147.3.2.9 Jabber functional requirements

147.3.3 PCS Receive

DRAFT 3.1 Figure 147-7

PROPOSED NEW FIGURE 147-7

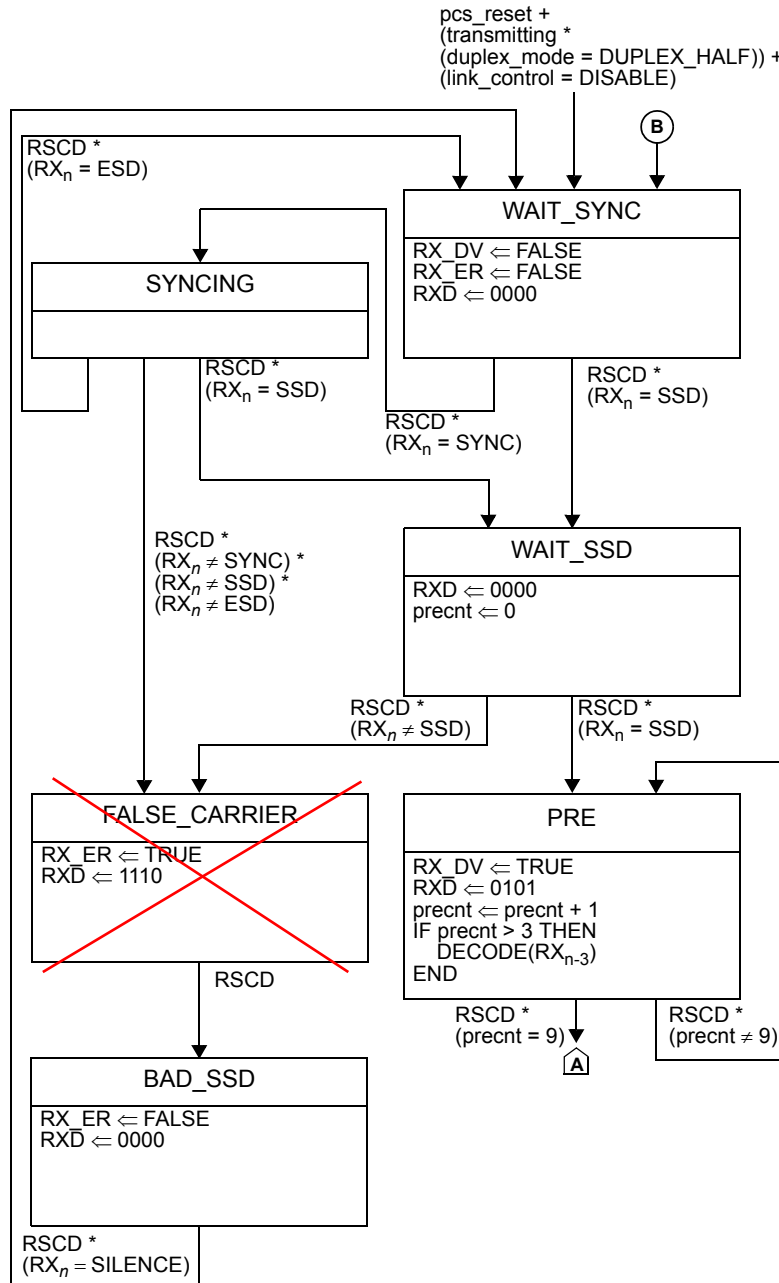
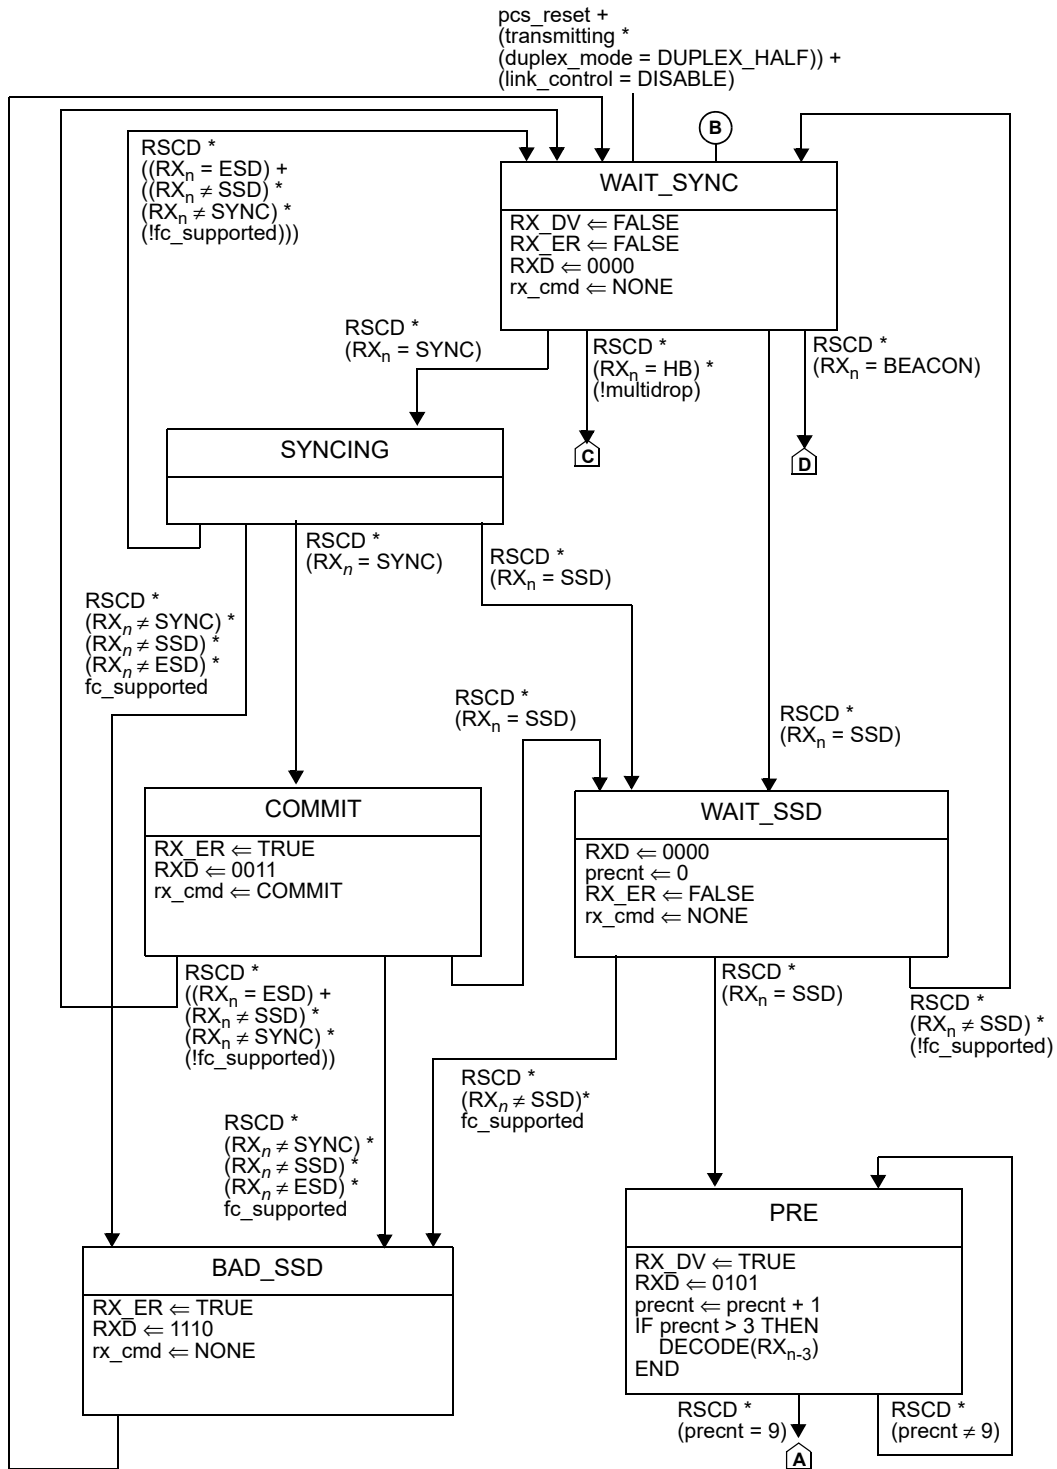
During the WAIT_SYNC state, the PCS notifies the RS of a received BEACON indication by the means of the MII as specified in 22.2.2.8. When a sequence of at least two consecutive 'N' symbols is received, the MII signals RX_DV, RX_ER, and RXD<3:0> are set to the BEACON indication as shown in Table 22–2. Additionally, the PCS notifies the RS of a received COMMIT indication by the means of the MII as specified in 22.2.2.8. When a sequence of at least two consecutive SYNC is received, the MII signals RX_DV, RX_ER, and RXD<3:0> are set to the COMMIT indication as shown in Table 22–2.

~~The PHY shall notify the RS of a received BEACON indication by the means of MII interface as specified in 22.2.2.8.~~

~~When a sequence of at least two consecutive 'N' symbols is received, the MII signals RX_DV, RX_ER, and RXD<3:0> shall be set to the BEACON indication as shown in Table 22-2, overriding the current state. Override shall cease as soon as the currently received symbol is anything other than an 'N' code.~~

~~The PHY shall notify the RS of a received COMMIT indication by the means of MII interface as specified in 22.2.2.8.~~

~~When a sequence of at least two consecutive 'J' symbols is received, the MII signals RX_DV, RX_ER, and RXD<3:0> shall be set to the COMMIT indication as shown in Table 22-2, overriding the current state. Override shall cease as soon as the currently received symbol is anything other than a 'J' code.~~

PROPOSED NEW FIGURE 147-8

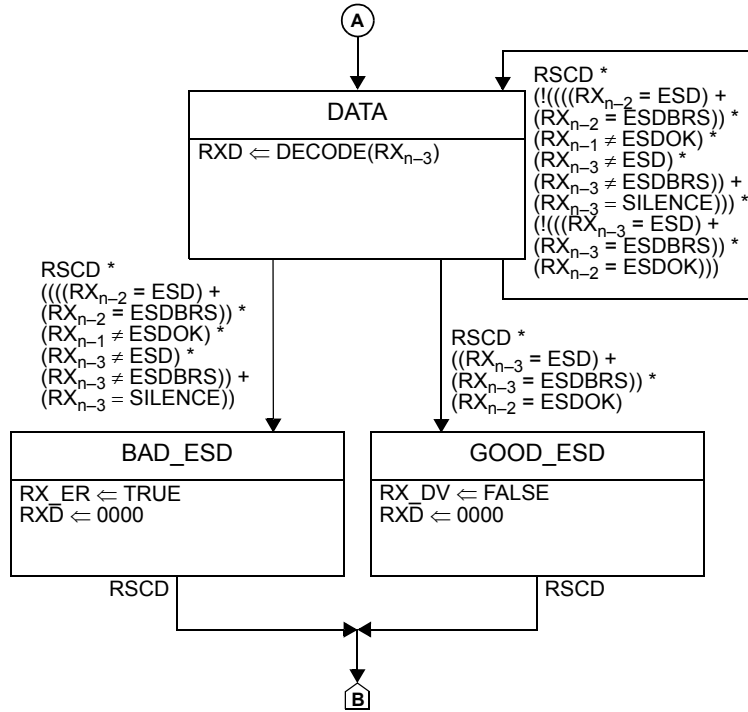
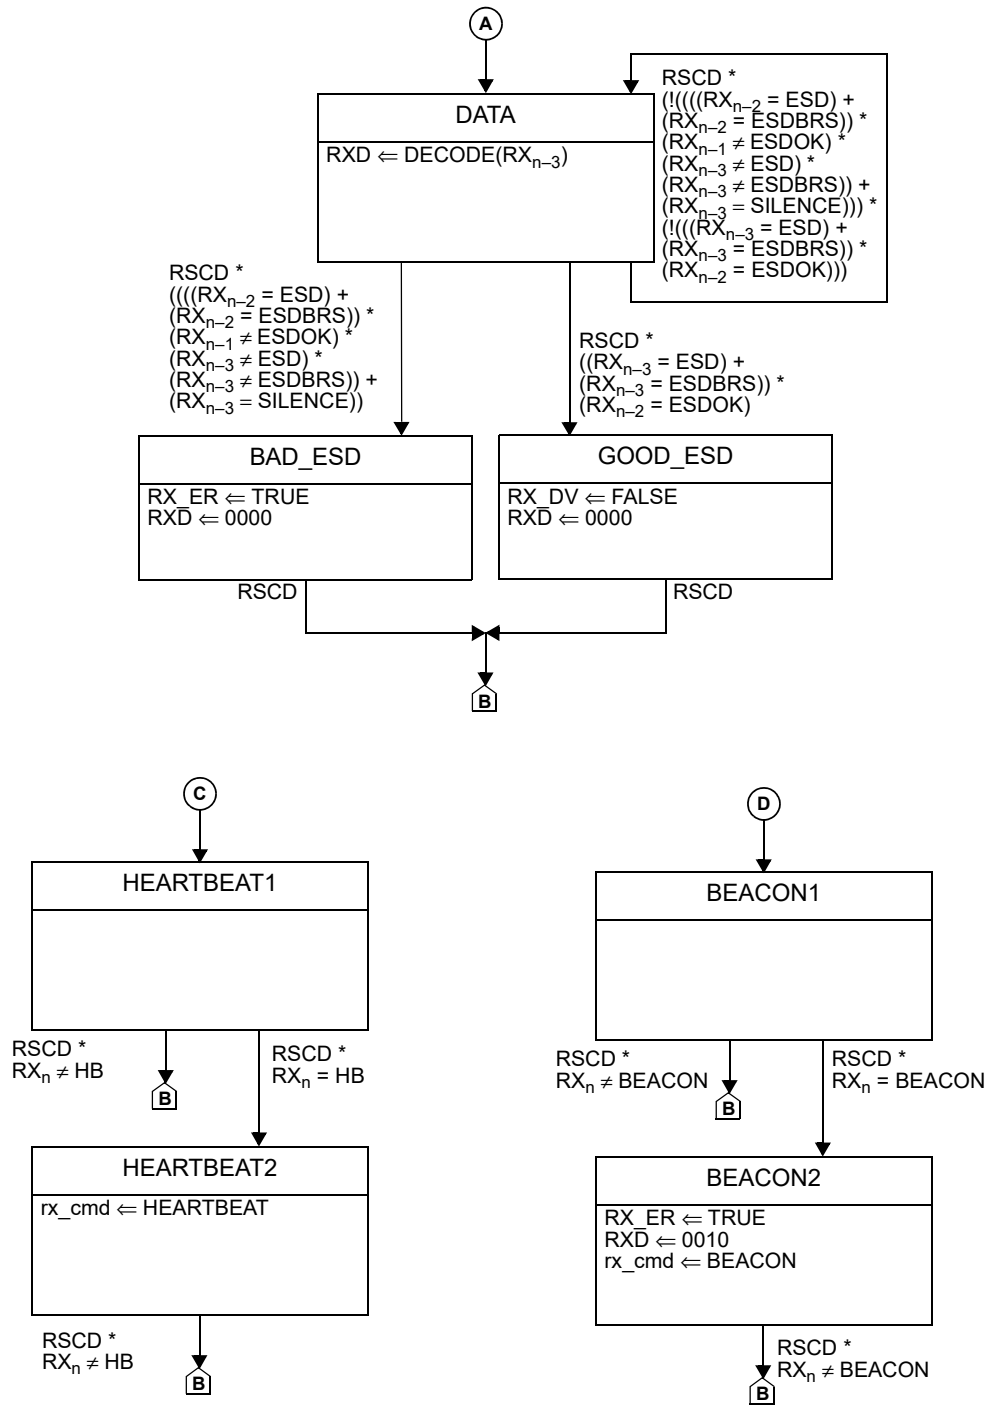
The DATA state, in which 5B symbols are decoded into MII data, is left when ESD or ESDBRS followed by either ESDOK, ESDERR, or ESDJAB symbol is encountered, or when the PMA detects SILENCE on the media (e.g. the transmitter prematurely stops data transmission).
